RE: Response to NYSDEC Comments
2011 PCB Pollutant Minimization Plan (PMP) Annual Report
SPDES Permit No. NY0001163

Response to NYSDEC Comments Made on March 22, 2012
RE: 2011 Annual PMP Report, February 1, 2012

FIGURE 1
MONITORING WELL NETWORK AT FACILITY
CARRER FACILITY THOMPSON ROAD
SYRACUSE, NEW YORK

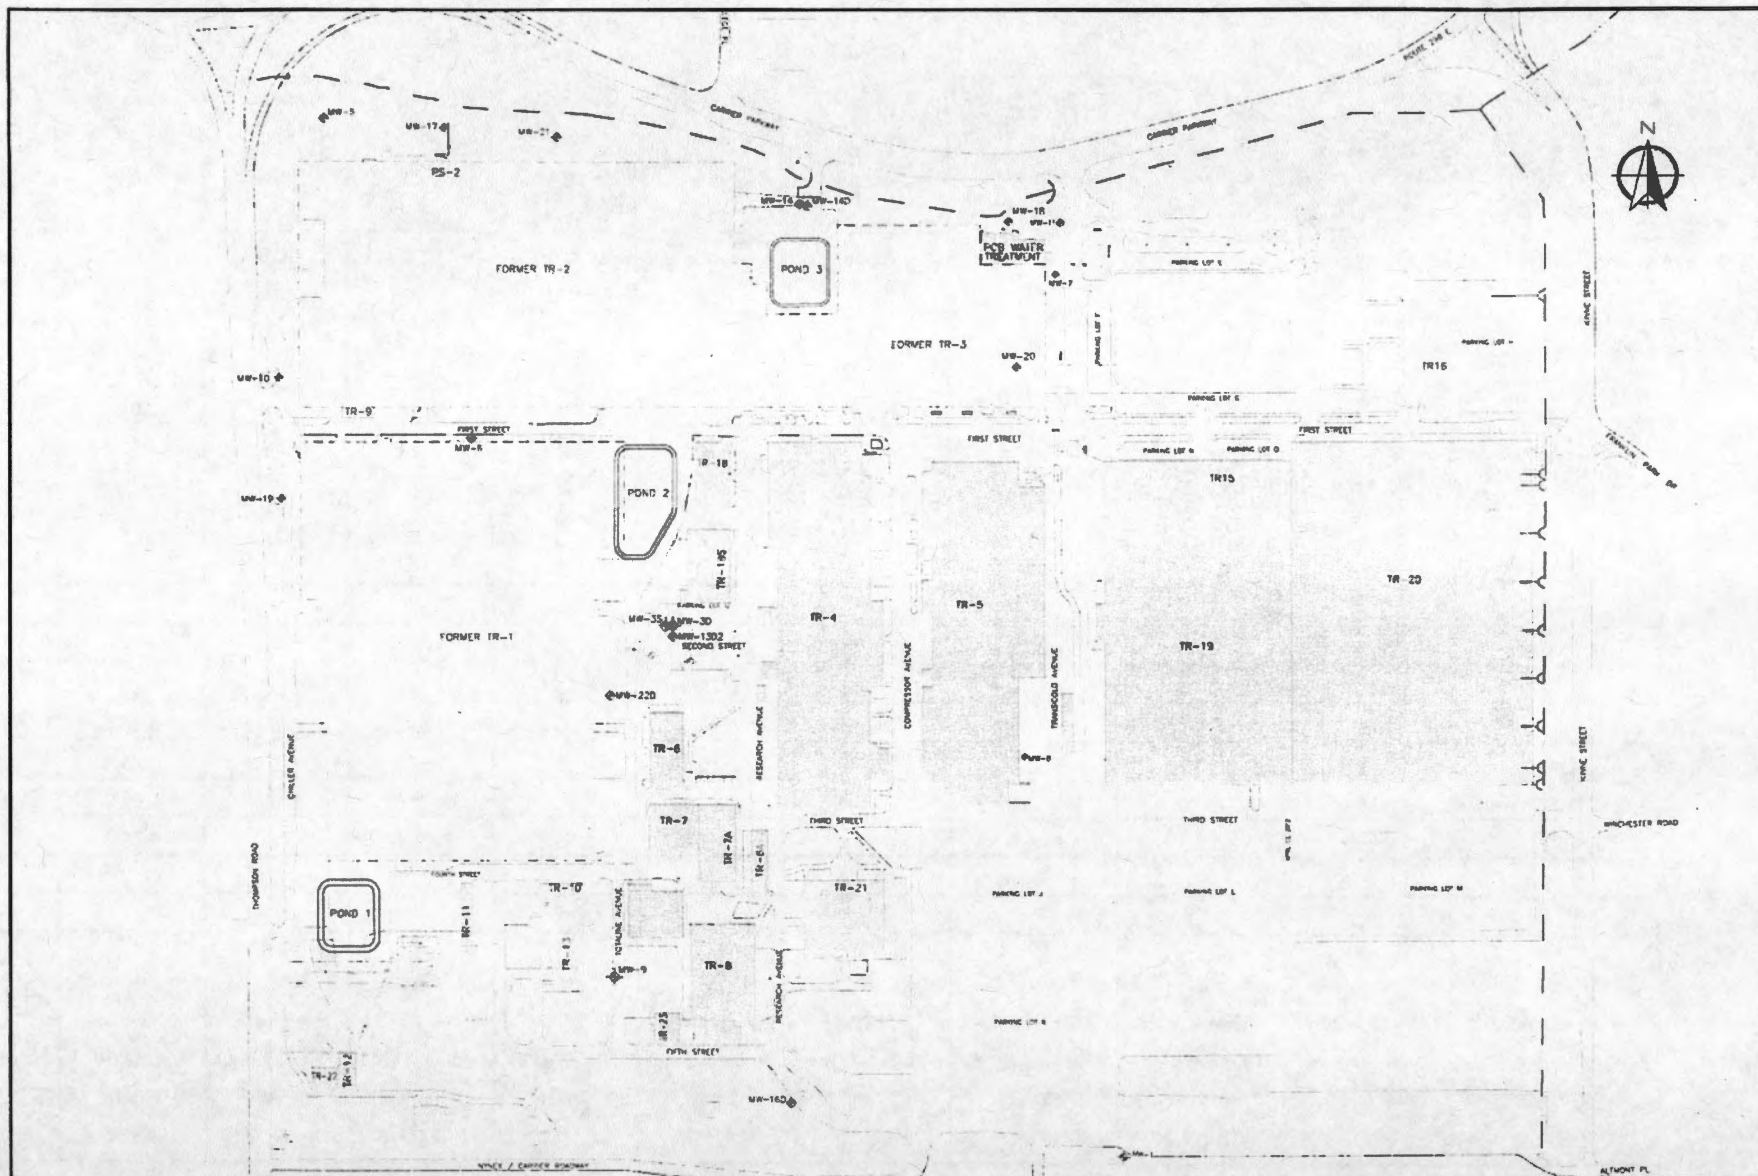
PPCB sampling of the on-site groundwater monitoring wells. PCB analysis must be done using either EPA Method 1668 or the Modified Green Bay method. Please submit your proposed sampling schedule, including a map that shows the location of the monitoring wells, to this office by April 2, 2012.

The attached table summarizes the historic PCB analysis of groundwater samples obtained from site groundwater monitoring wells (Figure 1 – Monitoring Well Network). A summary of sampling findings is listed below:

- In 1985, five groundwater monitoring wells (MW-1, MW-2, MW-3S, MW-3D, and MW-4) were sampled — PCBs were not detected in any sample.
- From 1994 to 2001, five groundwater monitoring wells (MW-1, MW-3S, MW-3D, MW-5, and MW-6 [MW-2 and MW-4 were abandoned earlier]) were sampled semi-annually — PCBs were not detected in any sample.

- In 2010, five groundwater monitoring wells (MW-5, MW-12, MW-14, MW-17, and MW-18) were sampled — PCBs were not detected in any sample. Note that MW-17 and MW-18 are installed in the bedding material of Outfalls 002 and 001, respectively.

- PCBs were detected in three of eight groundwater samples obtained from temporary wells installed as part of the Building TR-1 Sub-Slab Investigation of 2011. PCBs were not detected in temporary wells downgradient of these detections and therefore the areal extent has been defined to be a limited area. Additionally, analytical protocol required any sample with a PCB detection to be filtered and reanalyzed. PCBs were not detected in any of the filtered samples, indicating that PCB migration is through particle transport, not through dissolved phase transport.
